BD Micro Series Base Plate Earth Hole Position Modification

Fig. 1 Earth hole position

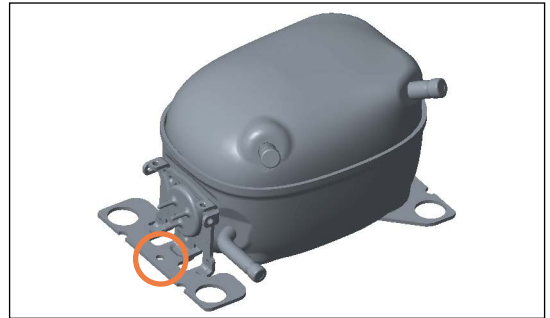
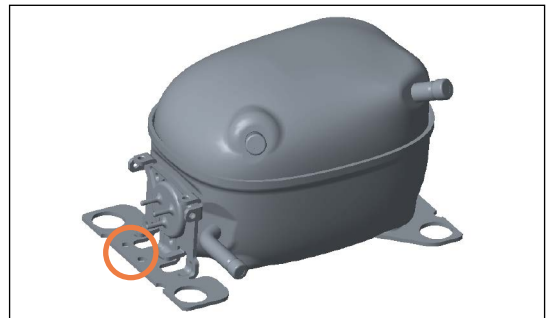
Until now, Secop offered its BD Micro series with an earth hole in the center of the left side base plate on all BD1.4F-AUTO/VSD/FSD, and PBC compressors (see figure 1).

As the screwdriver accessibility to the center hole is pretty limited, we will add another 15 mm next to the original one (see figure 2).

The modification will be introduced in calendar week 35, 2017. During the transition period some batches may include both versions for a brief period.

Customers using the current earth hole can change to the new one if their cable has the right length. Customers who choose not to use the earth hole will not be affected by this change.
